NEW FRONT ROAD SPRING/DAMPER COMPRESSOR TOOL

Section: 100

General Information

X100-27: This Technical Bulletin has been issued to inform the Dealer Network that a new front road spring/damper compressor tool (204-476) will be supplied with S-TYPE 2002 tool kits.

Fig. 1

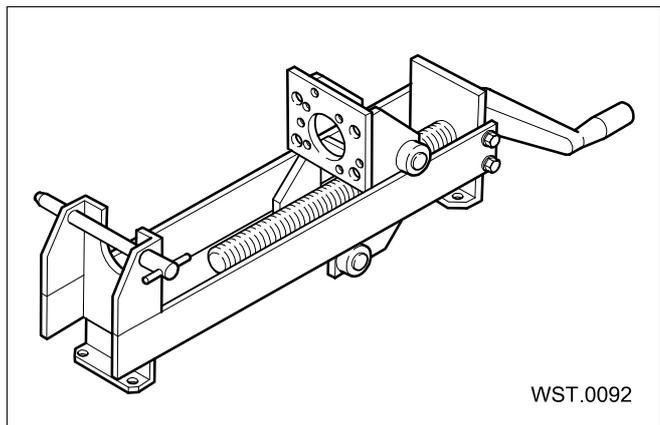
The new front road spring/damper compressor tool (204-476) **must be used** when compressing the front road spring/damper assemblies on **all** supercharged vehicles in place of the current road spring compressor (204-112). The top plate of the new front road spring compressor was designed to mate with all current XK, V8 XJ, S-TYPE and X-TYPE vehicles, and S-TYPE rear road springs.

Note: New front road spring/damper compressor tool (204-476). (See Fig. 1)
